In the matter of application for permit No. 63-32573 in the Name of M3 Eagle LLC

NACGUA's service of Ralston Hydrologic Services expert report: Hydrologic Analysis of the M3 Site: Supplement #1 Comments from Review of Geochemistry Report - Expert Report Prepared for the North Ada County Groundwater Users Association, January 2009

HYDROGEOLOGIC ANALYSIS OF THE M3 EAGLE SITE

Expert Report Prepared for the
North Ada County
Groundwater Users Association

Figure 1 Plan View Map (Figure 3 of Hydro Logic Inc, 2007)

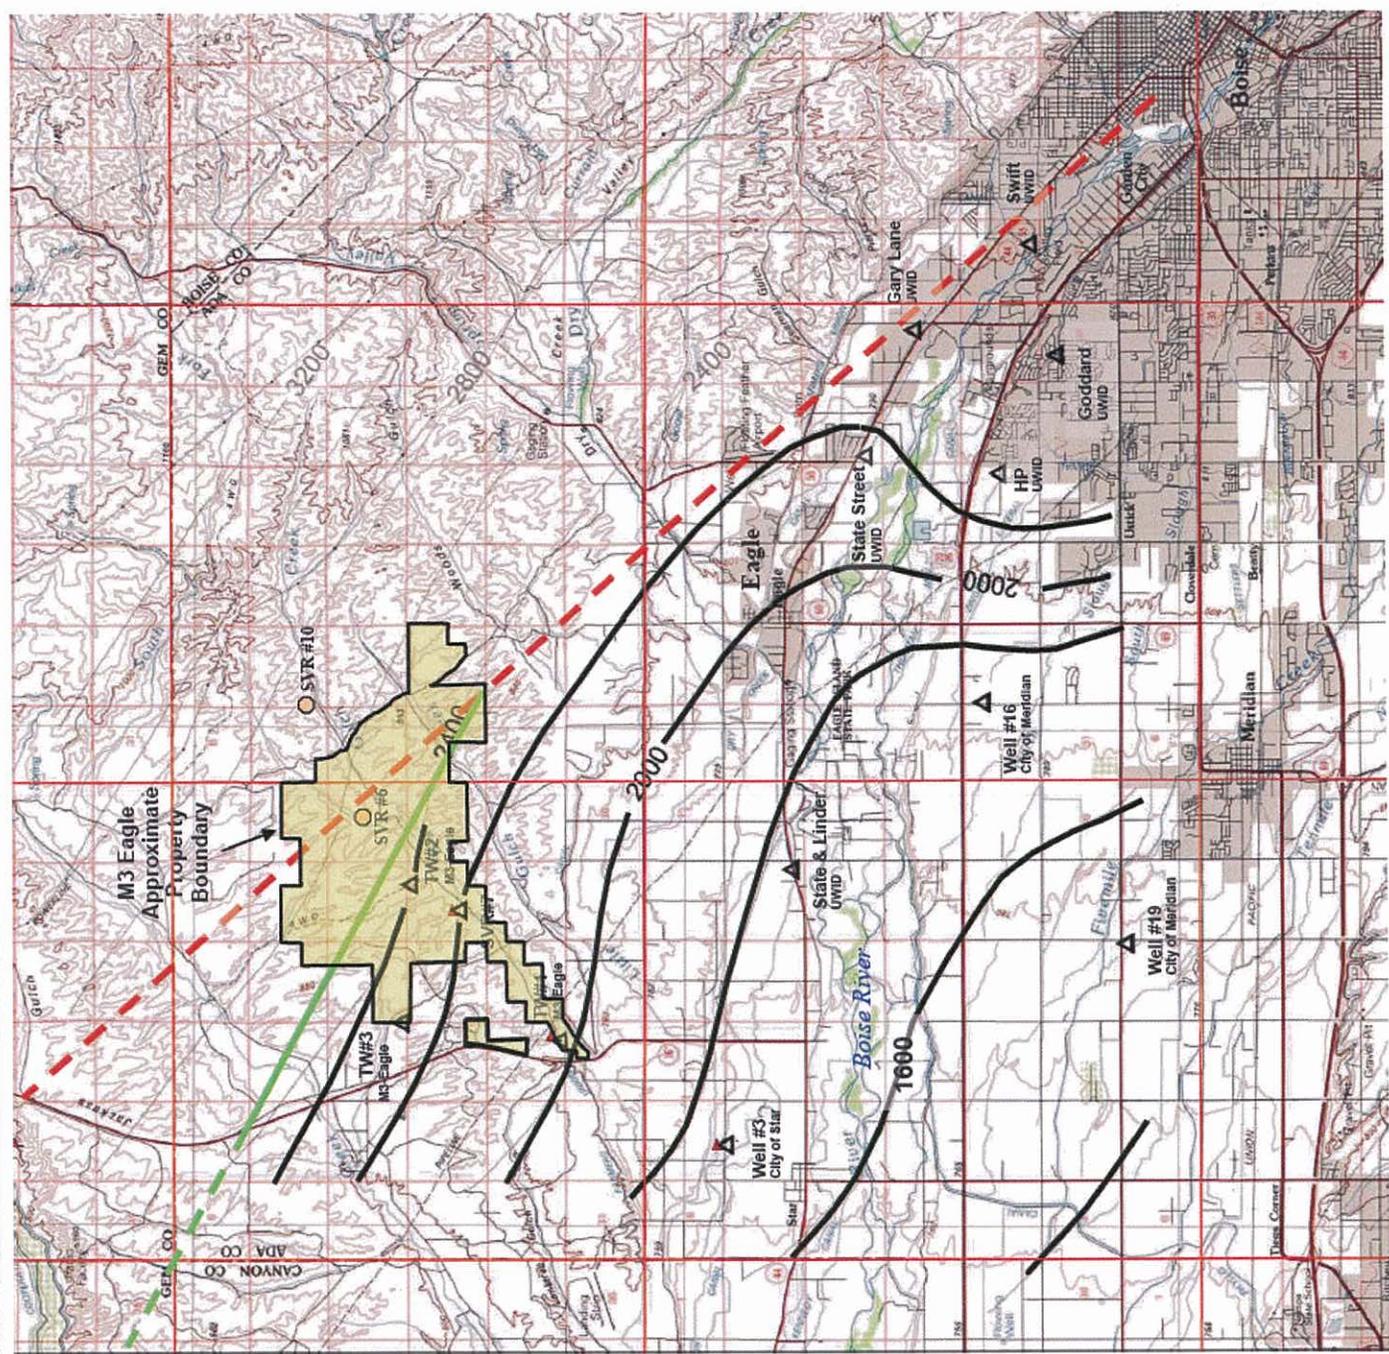
The location and nature of the unsaturated aquifer boundary northwest of the M3 Eagle property is poorly understood. The boundary is extended in a linear fashion to the northwest on Figures 1 and 3 taken from the 2007 Hydro Logic Inc. report. Figure 4 from Squires (2008) shows that the linear, northwest trending unsaturated aquifer boundary terminates slightly west of the range line separating range 1 west from range 2 west (R1W/R2W). The boundary of the Pierce Gulch Sand Aquifer extends on Figure 4 from the R1W/R2W line in a northwesterly direction and becomes approximately parallel with the southwest edge of the valley floor of Payette River. The hydrogeologic nature portion of the northern boundary west of the R2W/R1W line, as shown on Figure 4, is not explained in any of the Hydro Logic Inc. reports prepared to date. The boundary shown may or may not represent unsaturated aquifer conditions as are present in the M3 Eagle area.

- Extrapolation of the unsaturated aquifer boundary in a linear fashion in a west-northwest direction from the M3 Eagle site appears to be based on water level and geologic information from the Bond well located north of the mapped boundary and the Willowbrook Irrigation well located south of the mapped boundary (Figure 5). Squires (2008, Table 1) indicates that the Bond well had an August 2007 water-level elevation of about 2,358 feet, a depth of 503 feet and is completed in the Willow Creek Aquifer. According to Squires (2008), the Willowbrook Irrigation well had an August 2007 water-level elevation of 2,477 feet with the well completed in the Pierce Gulch Sand Aquifer. A well depth is not given for the Willowbrook Irrigation well in Table 1 of Squires (2008). A well driller's report was obtained from the IDWR on-line data base for an irrigation well constructed for the Willowbrook Water Corporation. This well is 400 feet deep, has screen sections in the depth interval of 250 to 340 feet and has a reported yield of 500 gpm with a drawdown of about 190 feet. It is not known if the well driller's report is for the well measured in 2007 by Hydro Logic Inc. The difference in water-level elevation between the Willowbrook Irrigation well and the Bond well plus the proximity to the M3 Eagle property appear sufficient to justify extrapolation of the unsaturated aquifer boundary from the M3 Eagle site to the vicinity of the Willowbrook Irrigation well.

- Essentially no hydrogeologic data are presented to support the boundary of the Pierce Gulch Sand Aquifer more than about one mile northwest of the M3 Eagle site, as shown on Figure 4. No data are available to document the continuation of the unsaturated flow boundary northwestward from the vicinity of the Willowbrook Irrigation well. The apparent termination of the unsaturated flow boundary near the R1W/R2W line as shown on Figure 4 is not supported by well data. No data are provided to support the depiction of northern boundary of the aquifer northwestward from the range line. No data have been presented that

Figure 2 Northeast to Southwest Hydrogeologic Cross Section
(Figure 5 of Hydro Logic Inc, 2007)

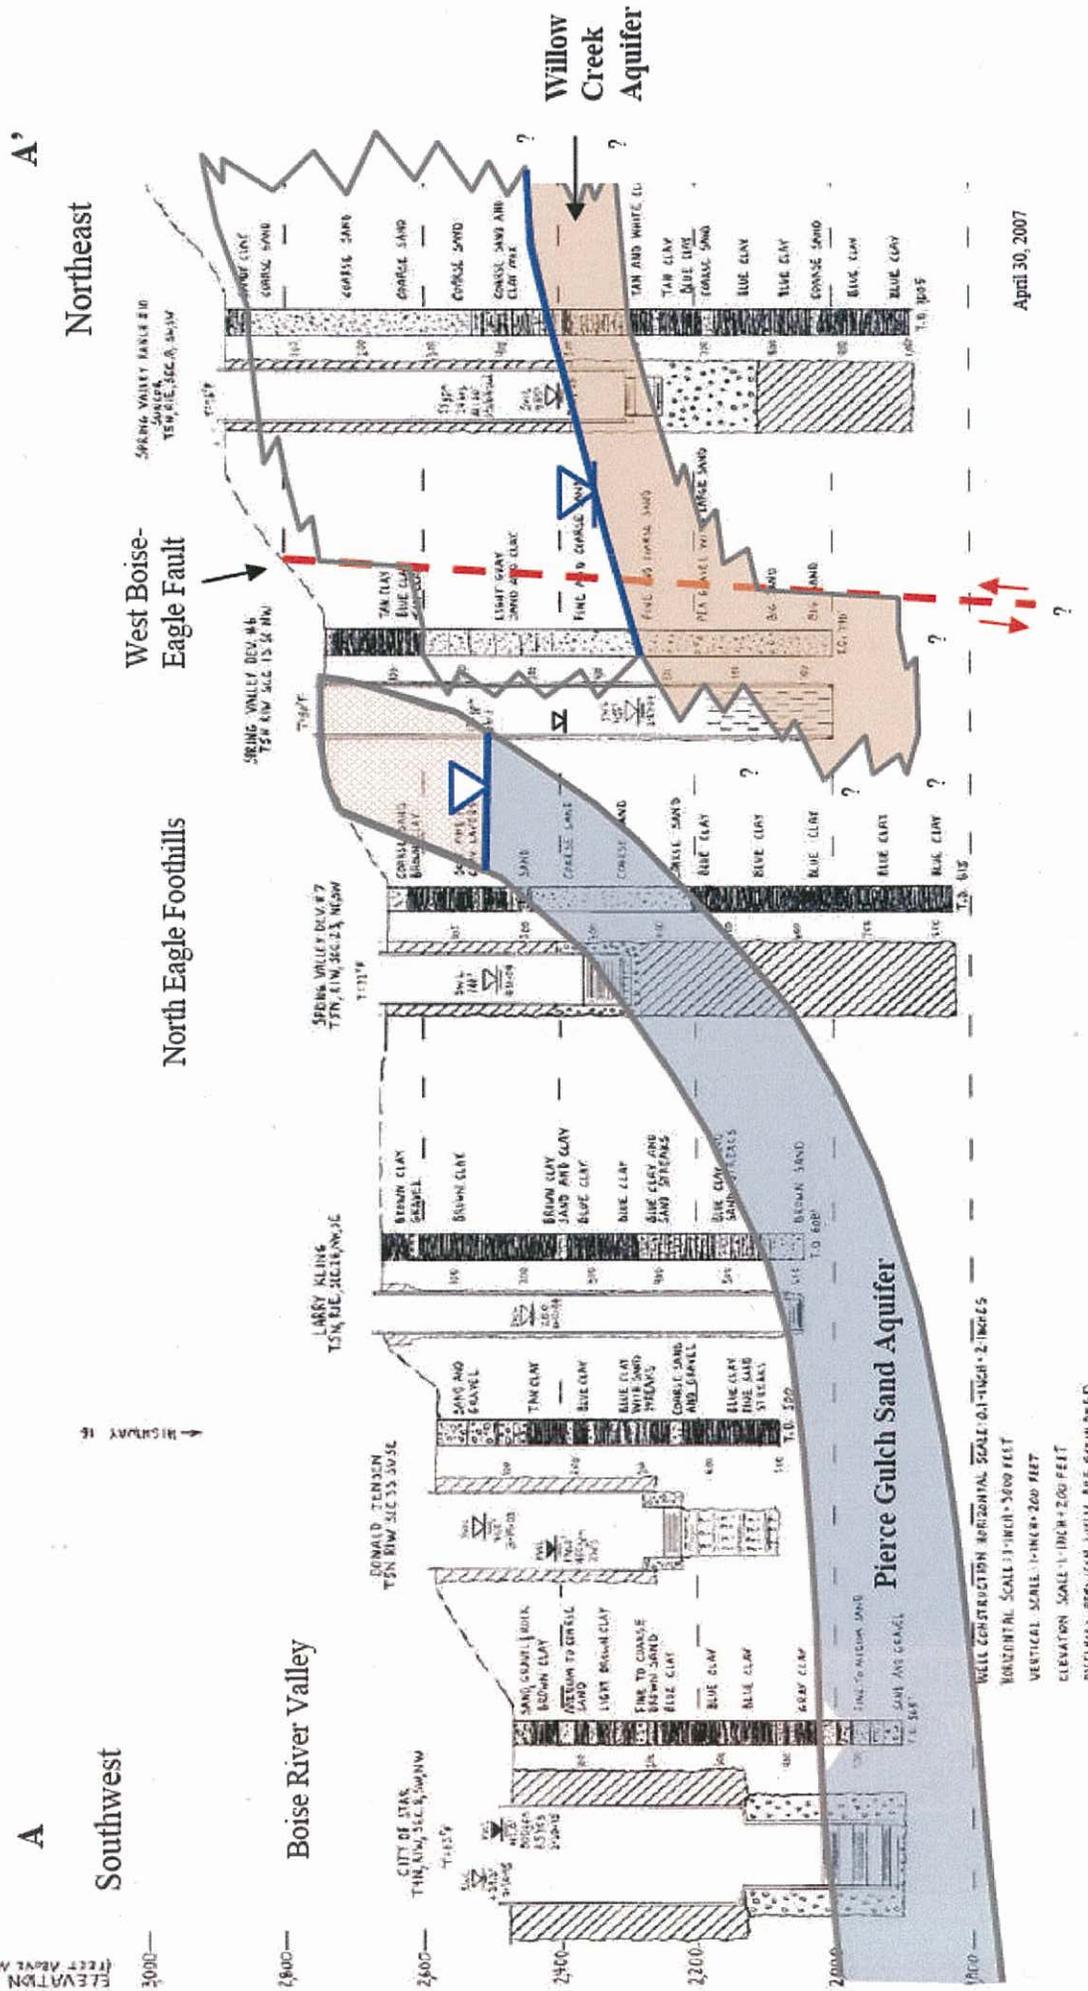
The unsaturated aquifer boundary occurs where the water-level elevation is the same as the elevation of the bottom of the aquifer. Figure 2 is a hydrogeologic cross section oriented northeast to southwest. This figure shows that the boundary is located in the vicinity of well SVR #6. Figure 8 is a draft hydrogeologic cross section oriented north-northwest to south-southeast. This figure shows that the unsaturated aquifer boundary occurs in the vicinity of M3 TW #3. The location of the unsaturated aquifer boundary based on these two cross sections fits well with the east-southeast to west-northwest boundary location shown as a solid green line on Figures 1, 3 and 4.

Figure 3 2006 Water-Level Contour Map (Figure 6 of Hydro Logic Inc., 2007)

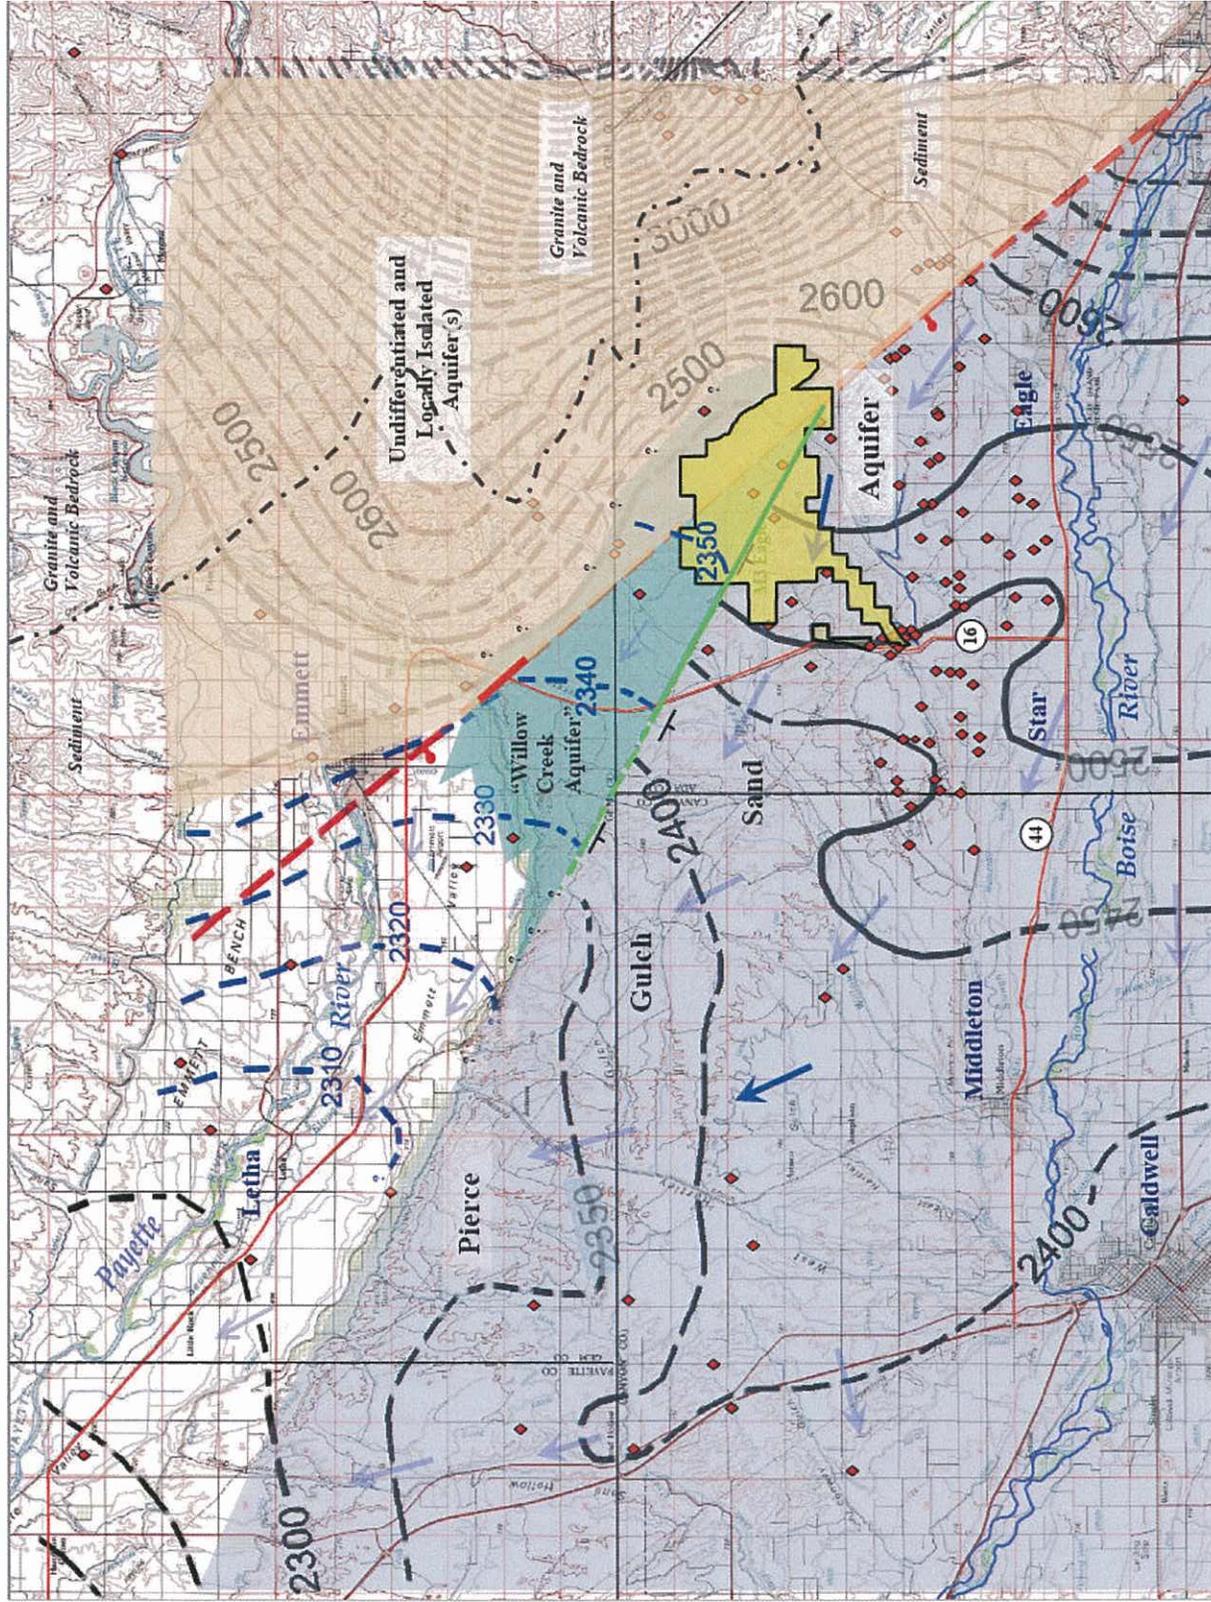
- Ground-water elevations shown on Figure 3 are lower in the Pierce Gulch Sand Aquifer than in the eastern upland sediment/bedrock aquifers located on the east side of the West Boise – Eagle Fault (shown as a red dashed line). This indicates that there is a hydraulic gradient from the upland sediment/bedrock aquifers to the Pierce Gulch Sand Aquifer.

- The ground-water elevations shown on Figure 3 in the Pierce Gulch Sand Aquifer are higher than in the Willow Creek Aquifer across the unsaturated aquifer boundary (shown as a solid or dashed green line). This indicates that there is a hydraulic gradient from the Pierce Gulch Sand Aquifer to the Willow Creek Aquifer.

- The ground-water elevations shown on Figure 3 in the Willow Creek Aquifer are higher than in the aquifer underlying the valley floor of the Payette River. This indicates that there is a hydraulic gradient from the Willow Creek Aquifer to the aquifer underlying the valley floor of the Payette River.

- The ground-water elevations shown on Figure 3 in the Pierce Gulch Sand Aquifer are higher than in the aquifer underlying the valley floor of the Payette River.

Figure 4 2007 Water-Level Contour Map (Figure 1 of Squires, 2008)

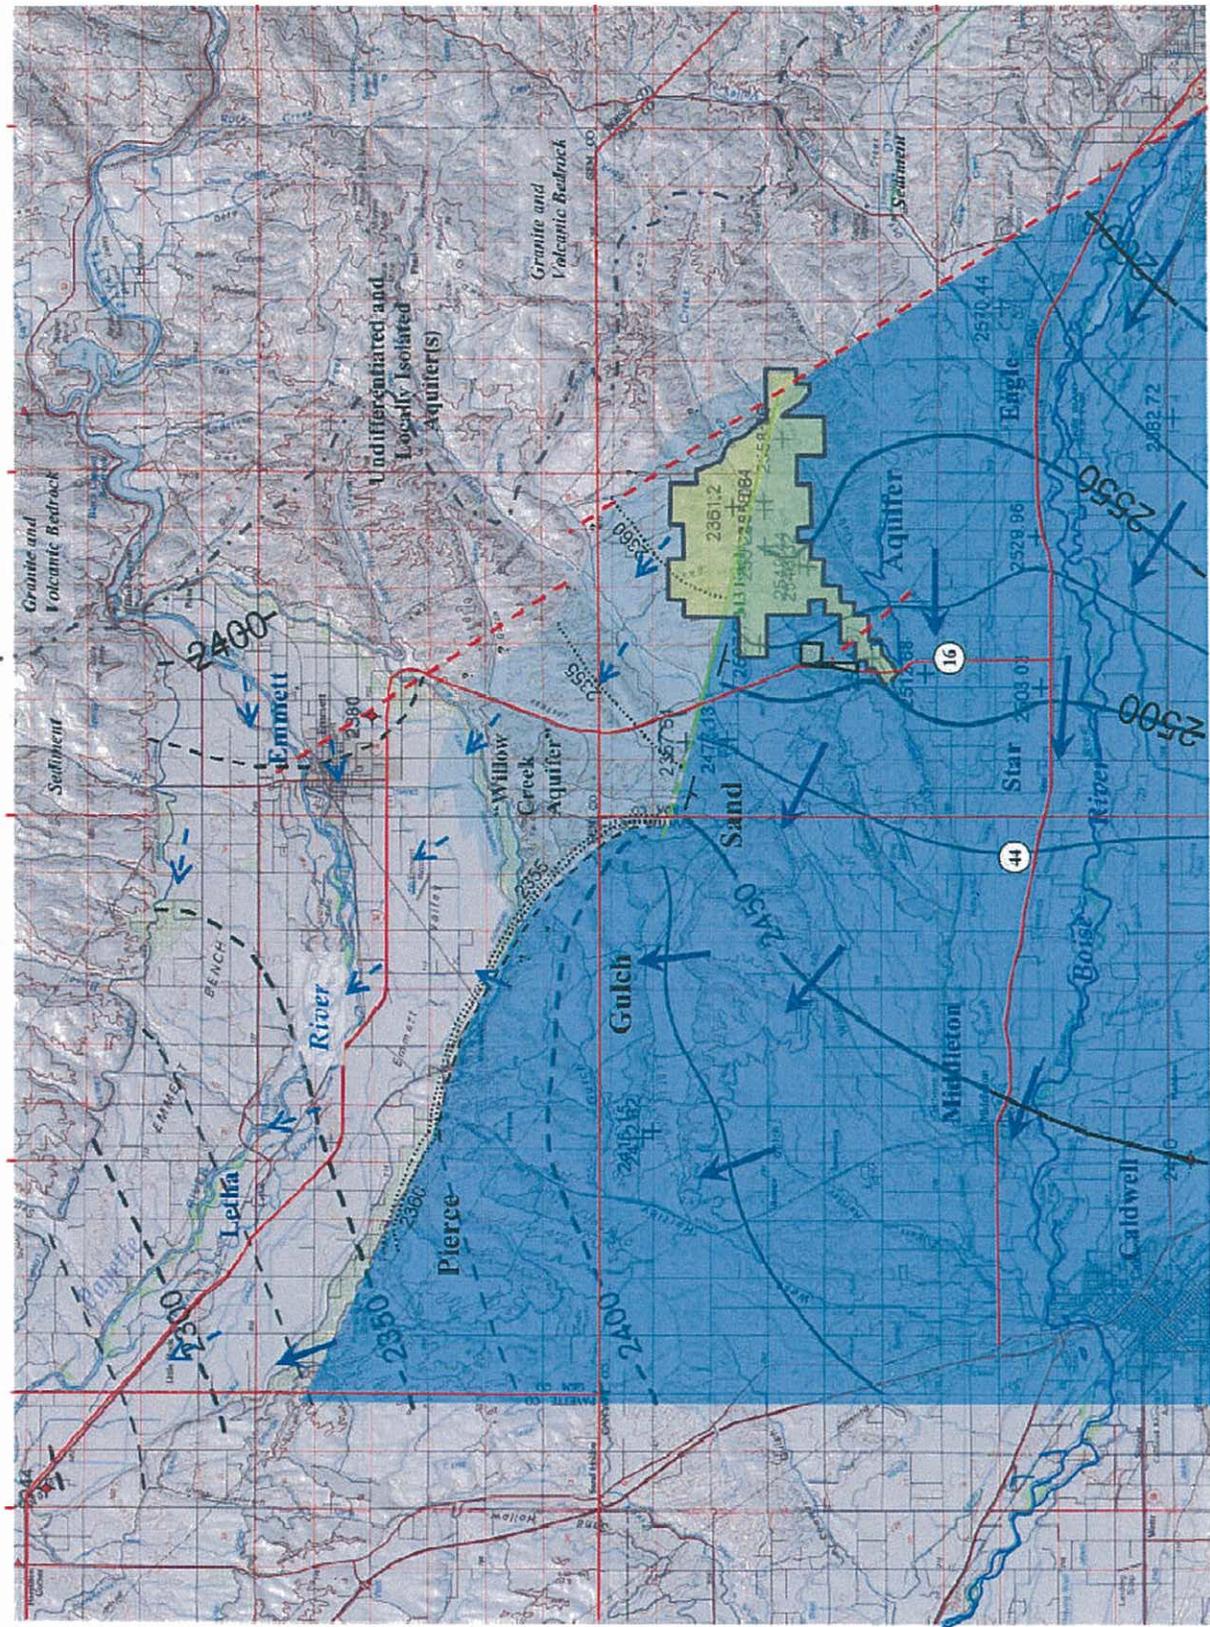
Squires (2008) presents a water-level contour map based on 2007 field measurements. The attached Figures 4 and 5 show the 2007 water-level contour map and the locations of wells where measurements were used to create the map. Water-level contours are given for the Pierce Gulch Sand Aquifer, the Willow Creek Aquifer and the aquifer underlying the valley floor of the Payette River. Fewer control wells were used for the 2007 map and the water-level contours are more generalized than for the 2006 map. Also, the water-level elevation contours for the Pierce Gulch Sand Aquifer are controlled in part by what appears to be the termination of the unsaturated flow boundary (green line) about three miles west-northwest of the M3 Eagle property.
